Subject: Transmittal of Correction to the Revised Version of Description of the
Total System Performance Assessment and Integration Issue
Resolution Blueprint—IM 20.01402.761.140

**DESCRIPTION OF THE TOTAL SYSTEM
PERFORMANCE ASSESSMENT
AND INTEGRATION ISSUE
RESOLUTION BLUEPRINT**

**Center for Nuclear Waste Regulatory Analyses
San Antonio, Texas**

Corrosion rates tend to decrease with test duration, why?

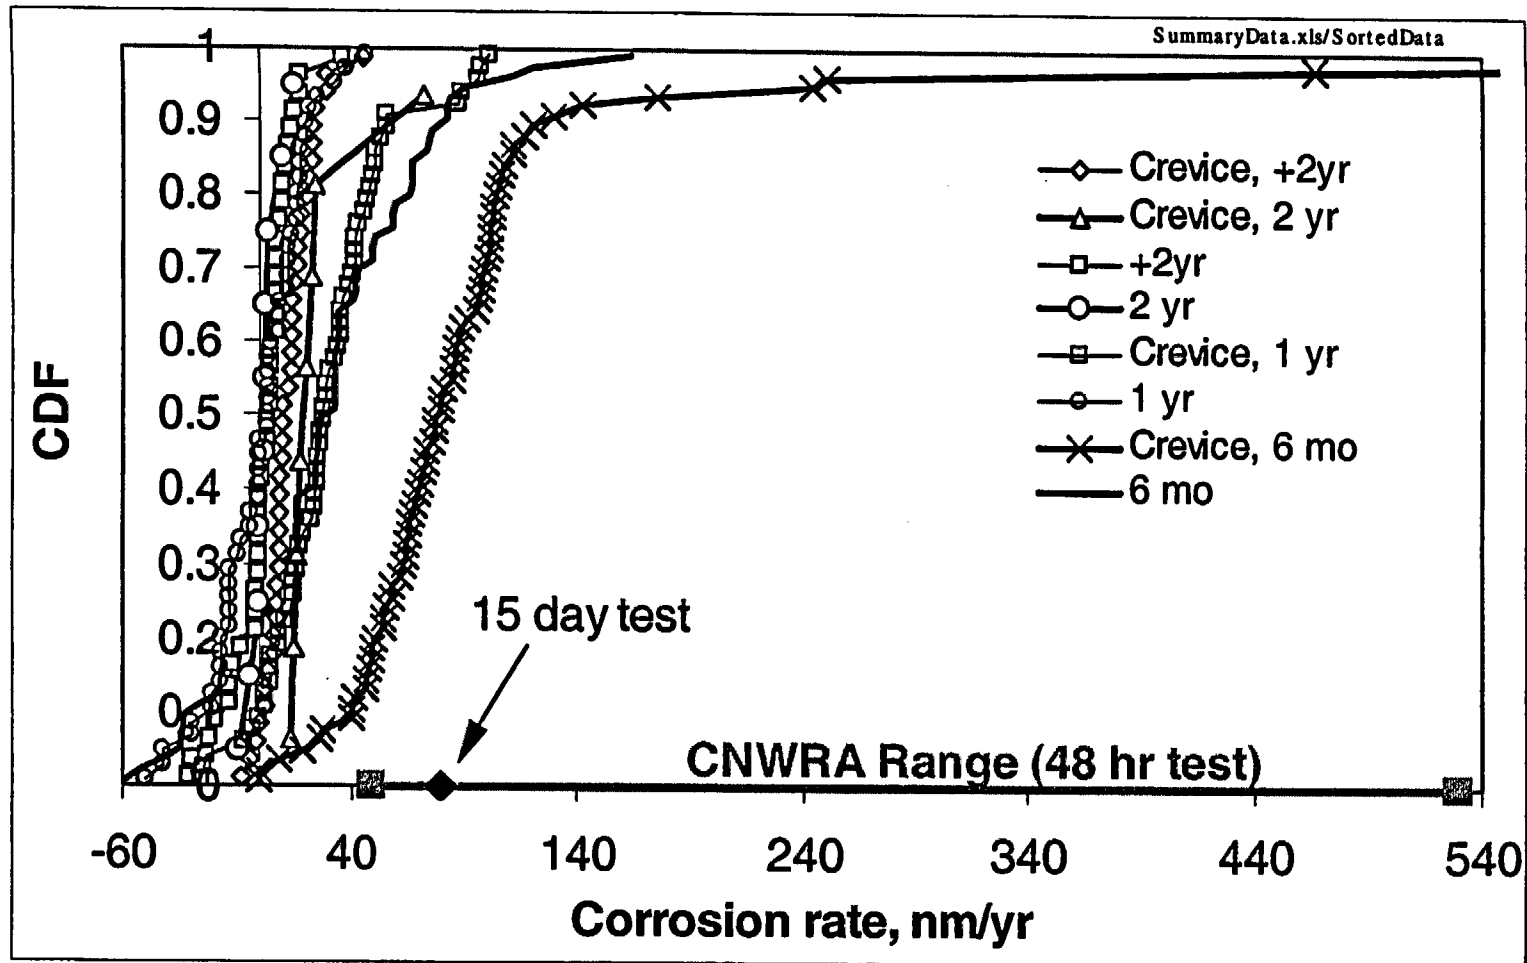
Corrosion rates tend to decrease with test duration, why?

- Deposition of corrosion products producing “weight gain” may compete with dissolution through the film producing “weight loss,” thus weight loss measurements may underestimate corrosion rates. Deposits have been observed on Alloy 22 under transpassive conditions (Dunn et al., Corrosion 2001, Paper 01125).
- Do silica deposits form an insulating coating? Is it possible that the apparent decrease in the corrosion rate is due to a decrease in the extent of the reactive surface area? Longer term testing tended to yield more samples with weight gain.

Results

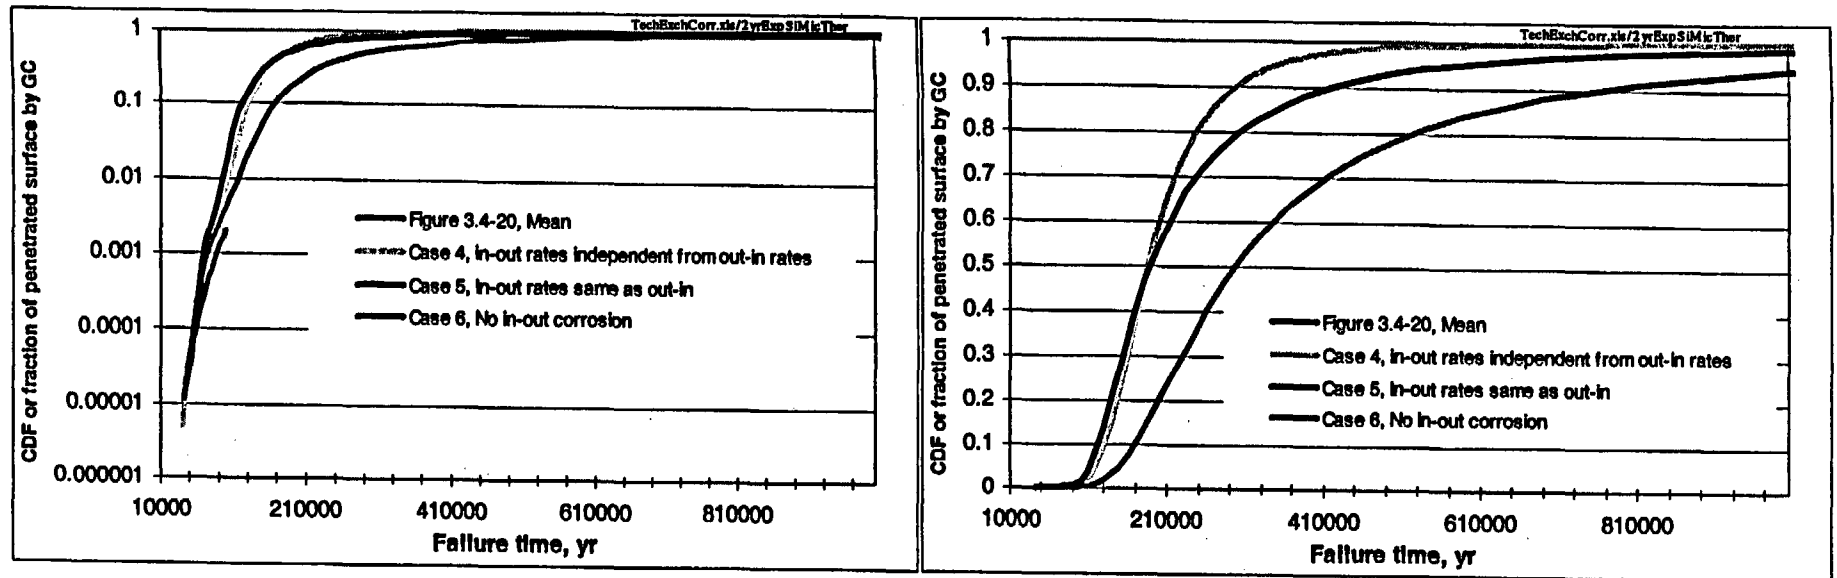
The results seem consistent. Estimates of the fraction of WP surface penetrated by general corrosion are slightly above DOE results reported in the TSPA-SR, p. F3-62, up to a factor of ~10 at 100,000 yr.

Figure 3.4-19. Degradation Profiles for Time to First Failure: Drip Shield Patch, Waste Package Crack, Waste Package Patch

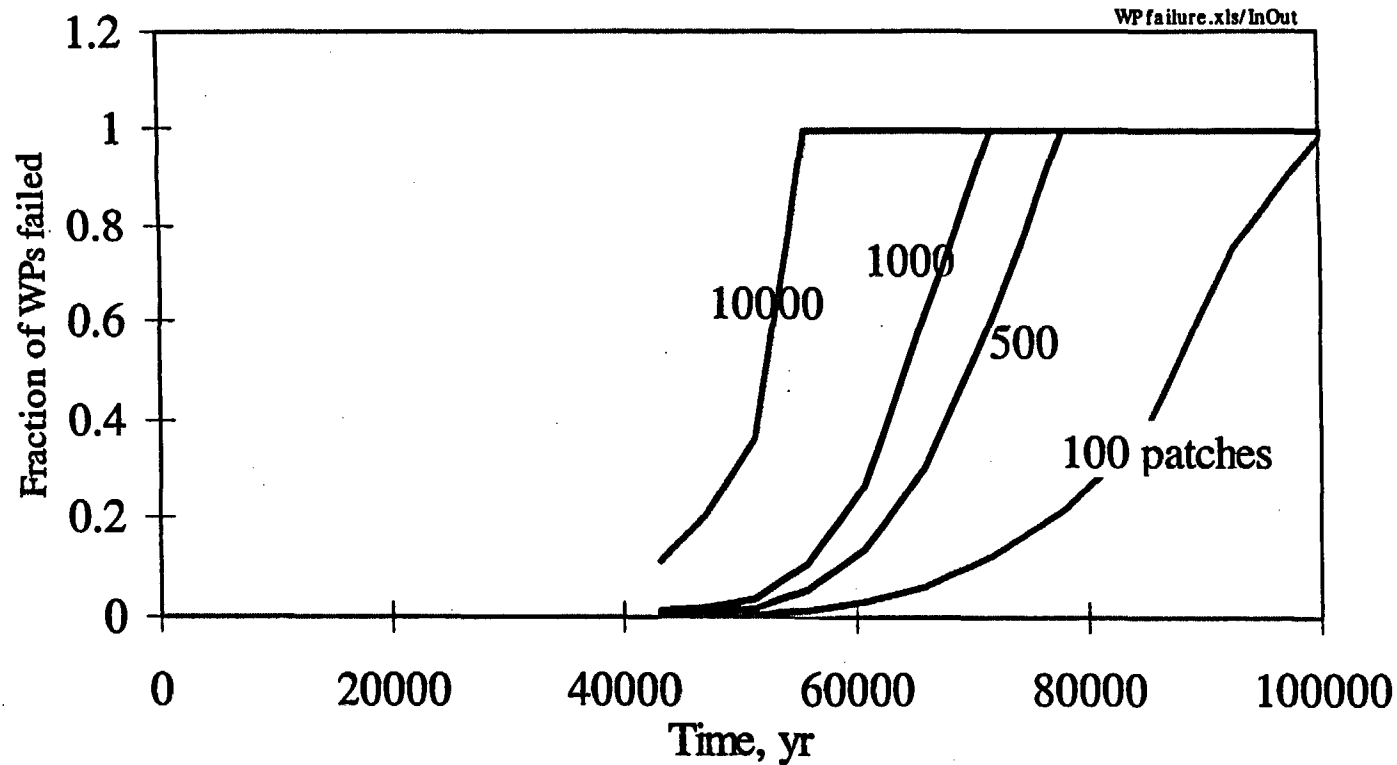
Curves in this figure (from TSPA-SR, TDR-WIS-PA-000001 Rev 00 ICN 01), are not well-defined.

The fraction of WPs failed (1st patch penetration) is an ill-defined quantity. It depends on the number of assumed patches on the WP surface.
